CPCA/Jacobs' Review of Cambourne to Cambridge

This paper provides a response from the Greater Cambridge Partnership (GCP) to the paper produced by Jacobs on behalf of the Cambridgeshire and Peterborough Combined Authority (CPCA) in order to assess the compliance of the Cambourne to Cambridge scheme (C2C) with the Cambridgeshire Autonomous Metro (CAM).

Figure 1 - Phase 2 public consultation brochure page 3

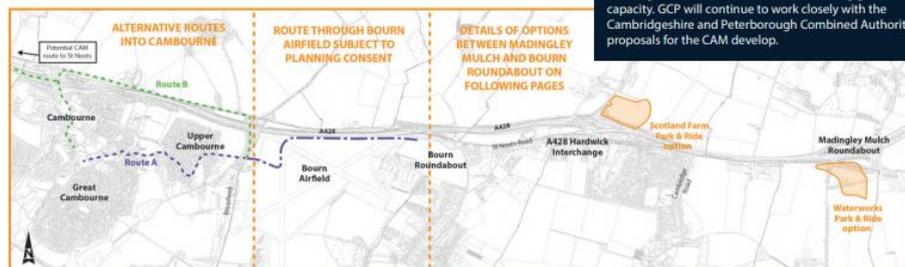
- C2C be designed to connect to East West Rail Station at Cambourne and a segregated route around Cambourne be examined.

GCP agreed with ARUP in 2018 that CAM would ultimately require a segregated route around Cambourne. A consultation on options for a Phase 2 route running from Madingley Mulch roundabout and on to Cambourne was undertaken in February/March 2019. Phase 2 consultation materials³, which CPCA Officers contributed to, presented what a future, CAM-compliant, Phase 2 route continuing to Neots would look like (Route B) – see Figure 1.

C2C is, however, developed as a free-standing scheme and no detailed off-line alignment around Cambourne has been proposed as yet because:

- 1 There is no agreed location for the East West Rail Station at Cambourne
- 2 There is no clarity as to the likely onward CAM alignment to St Neots

As and when the above issues are resolved GCP can agree an alignment around Cambourne. In the meantime the proposed alignment does not impede eventual delivery of CAM.
